Swanwick Airspace Improvement Programme
Airspace Development 5
Proposed changes to LAC West to improve ATS route connectivity

SAIP AD5
Documentation:
Stage 4 Update and Submit

Step 4A Update Design

Figure 12 Q60 and L18 MORAG/LIPGO to DIKAS/UGNUS final proposal – see para 3.7.4

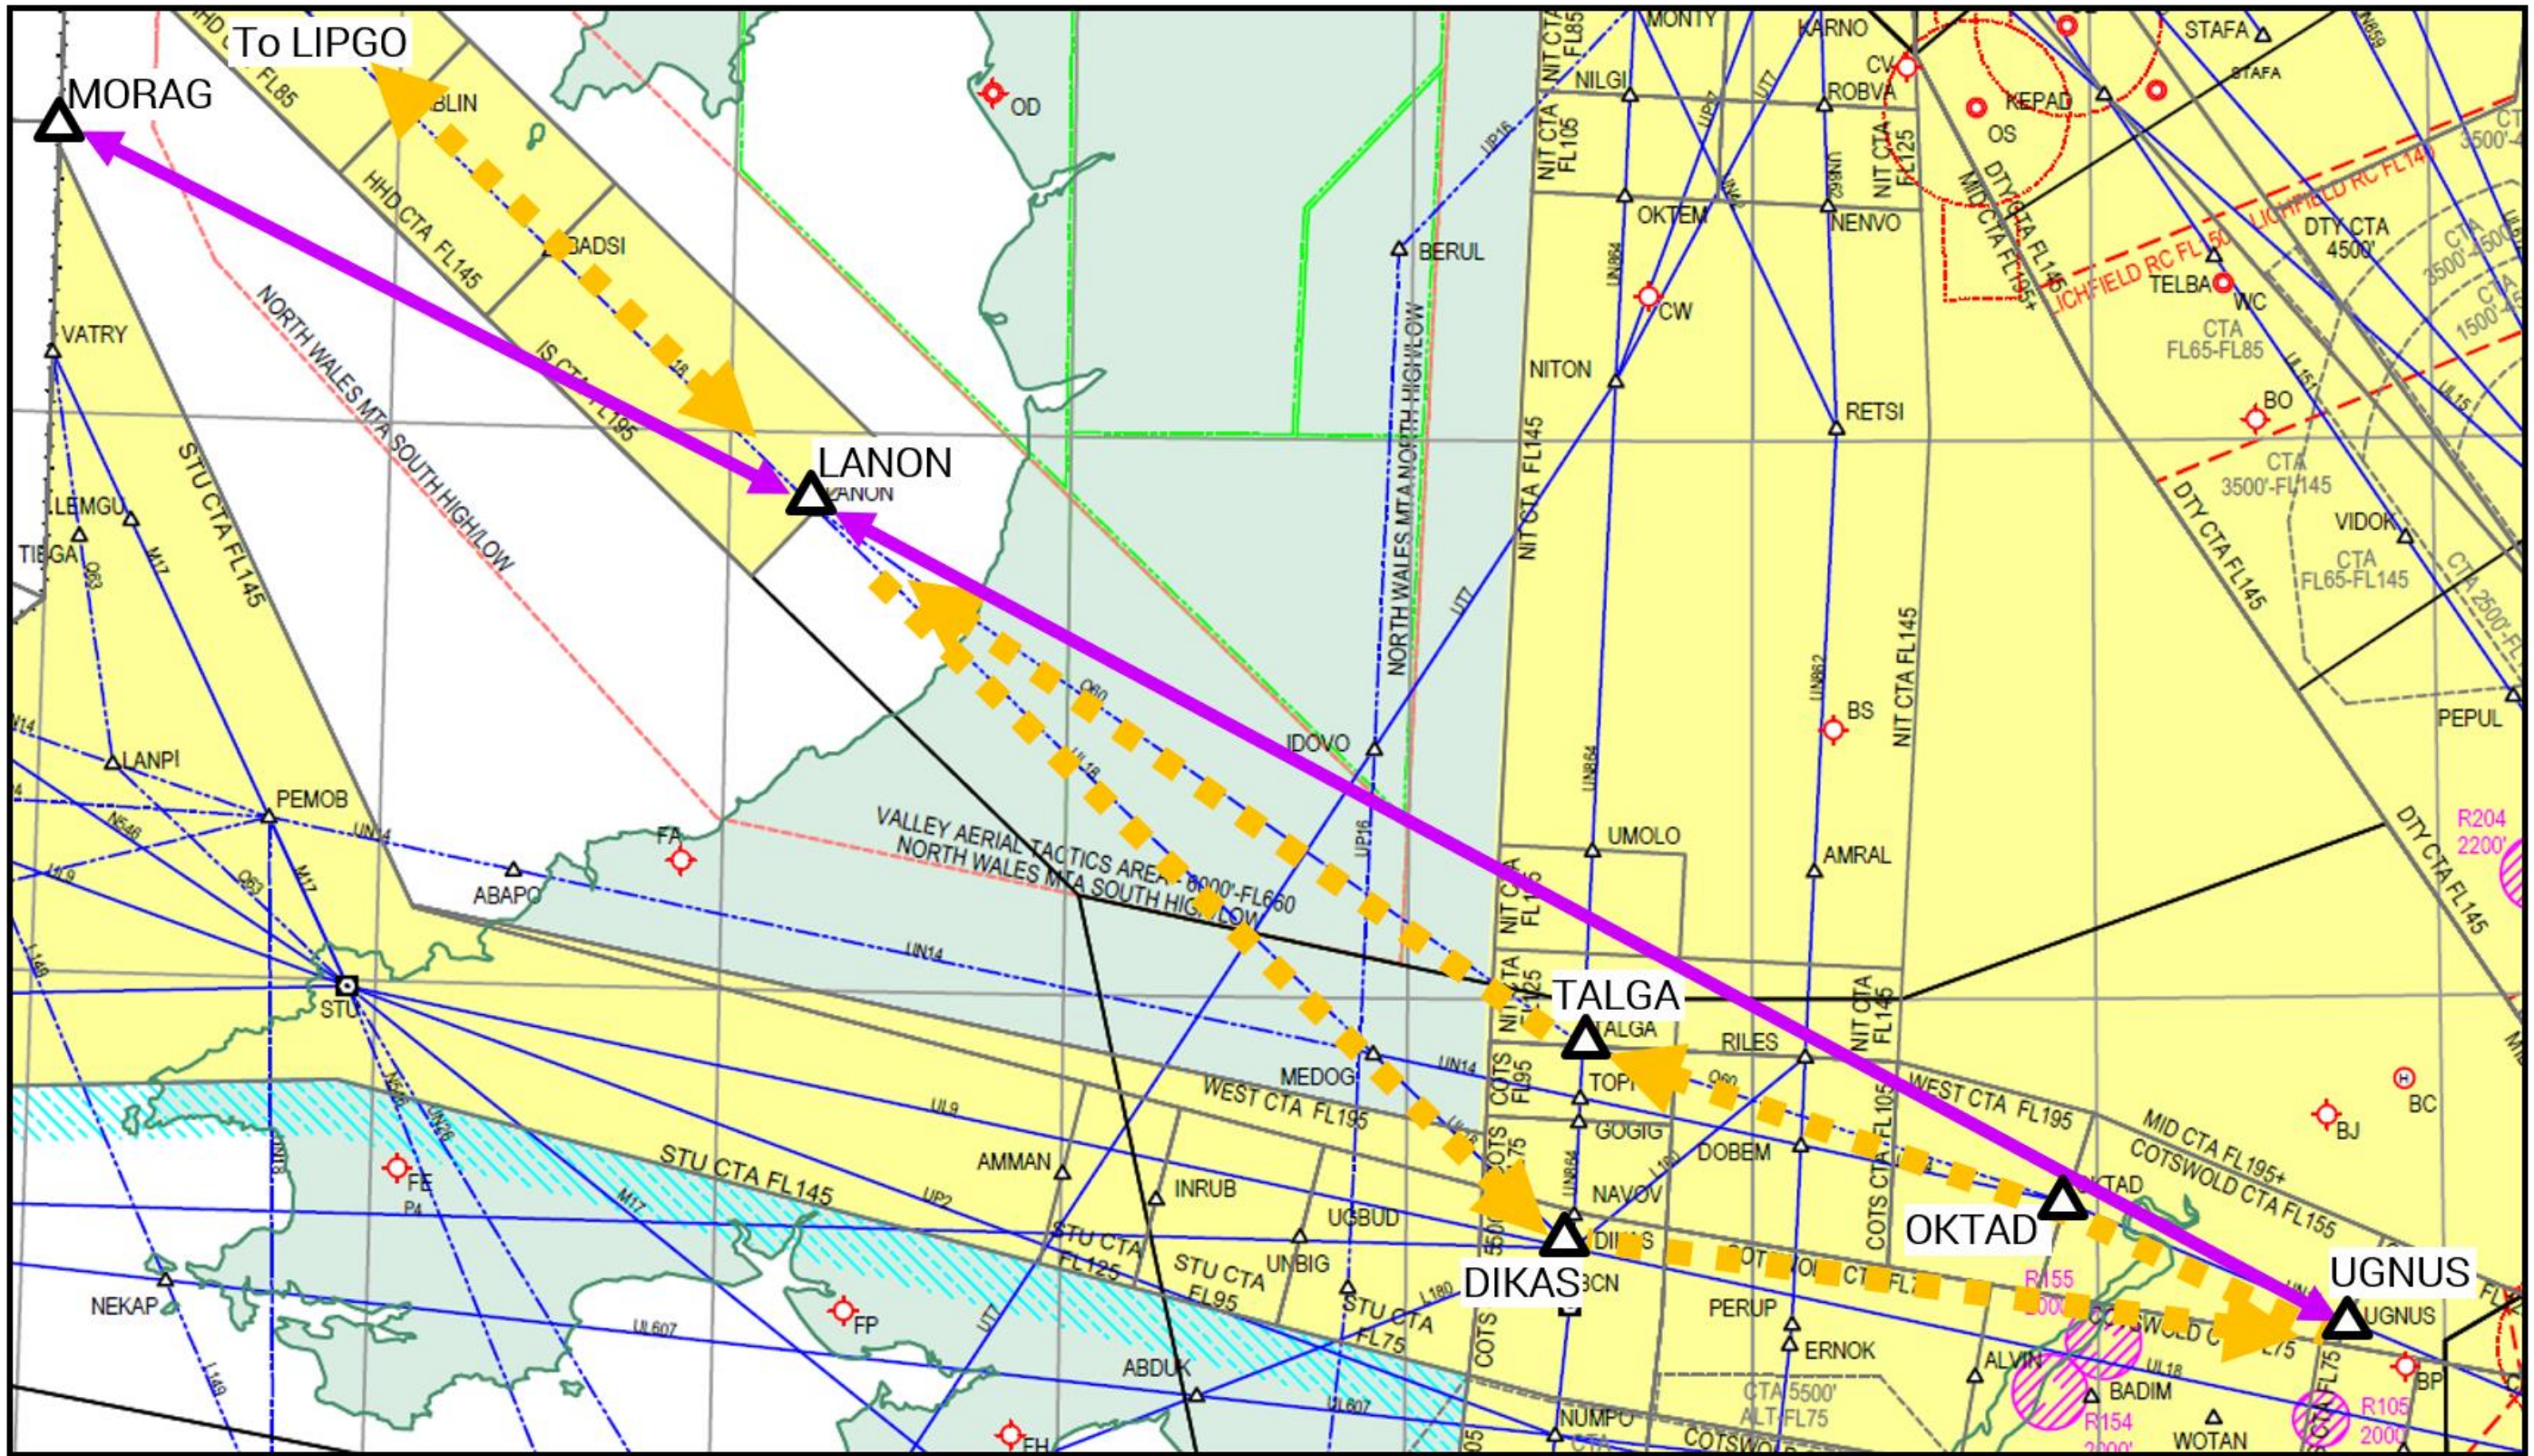
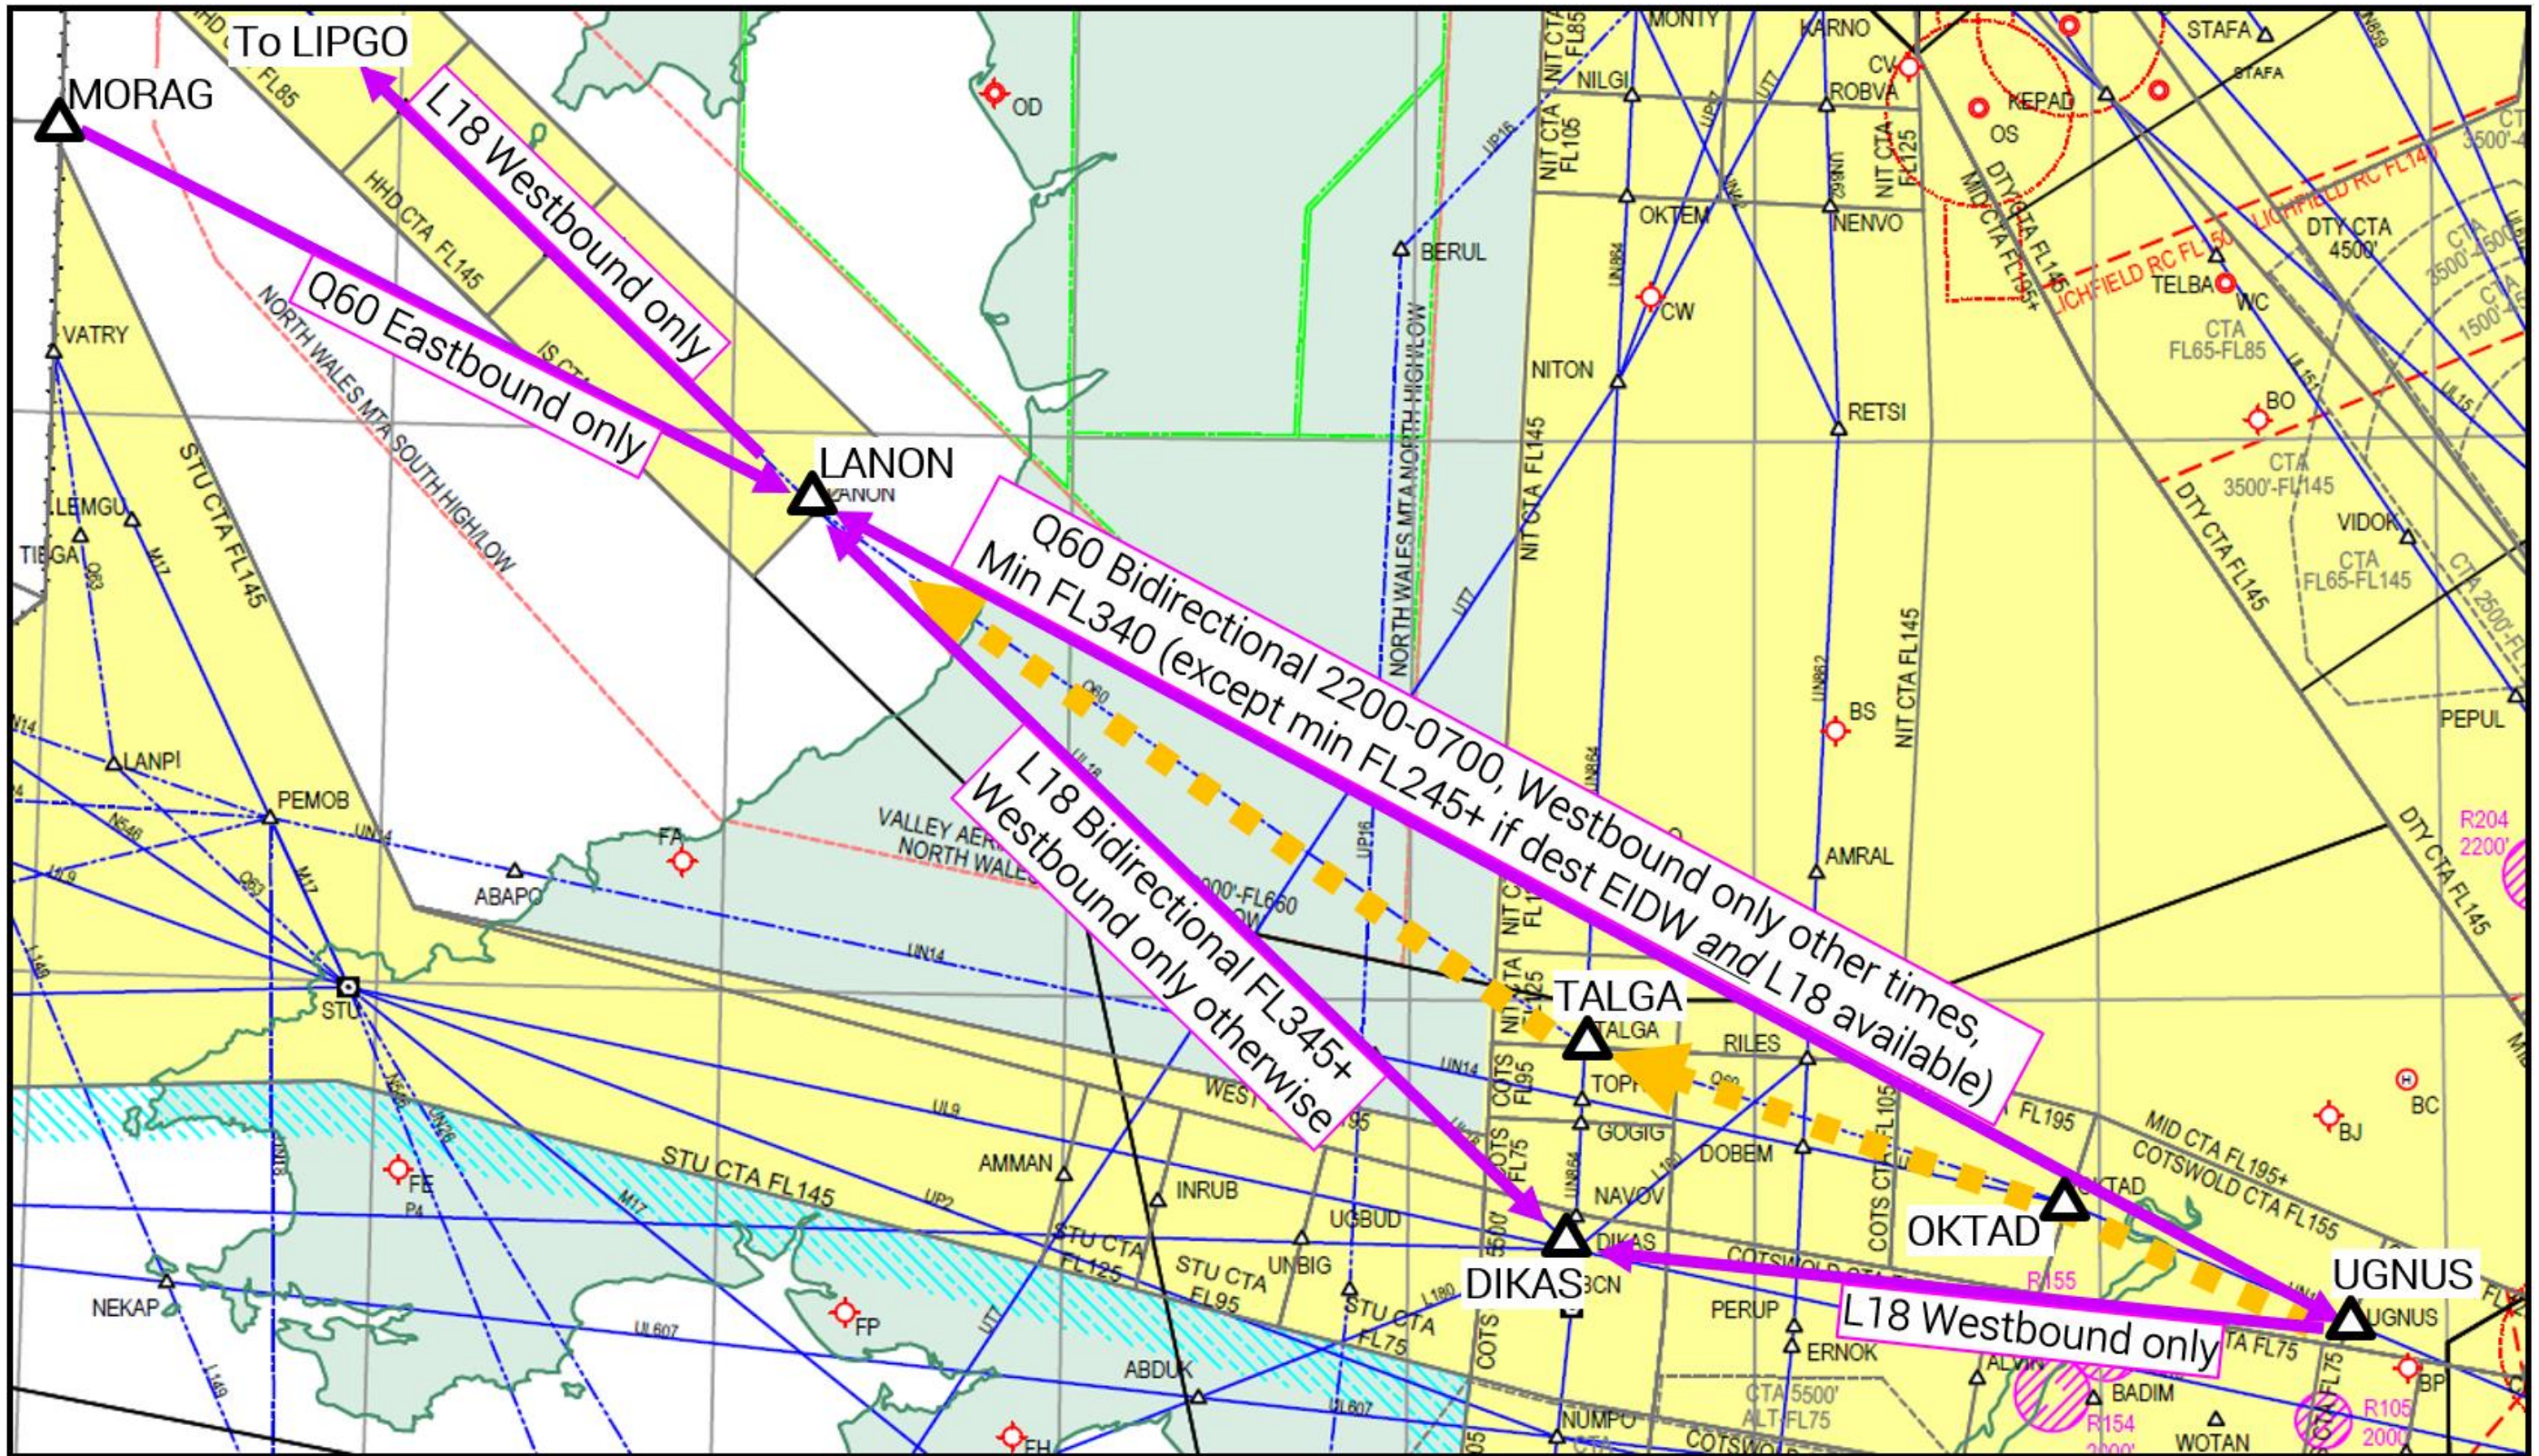
Consultation document Figure 11, this document Figure 11 on page 19 and Figure 12 on page 20.

The consulted-upon structure would be more complex to manage in the LANON area. The exact same route structure is proposed, but with changes to the directionality of some flows and a new minimum FL340 for Q60 (except for Dublin arrivals which use the route FL245+ provided L18 is available). The general route orientation in the area now becomes westbound via L18 LIPGO and eastbound via MORAG, with route segments east of LANON for both routes now set to bidirectional at certain times/FLs, better balancing and reducing the complexity of these flows.

These flow and level restrictions reduce some of the opportunities for savings because some lower flights were originally eligible for the shorter Q60 but must now follow the original longer route (except Dublin arrivals which remain eligible). There is thus a slightly reduced benefit.
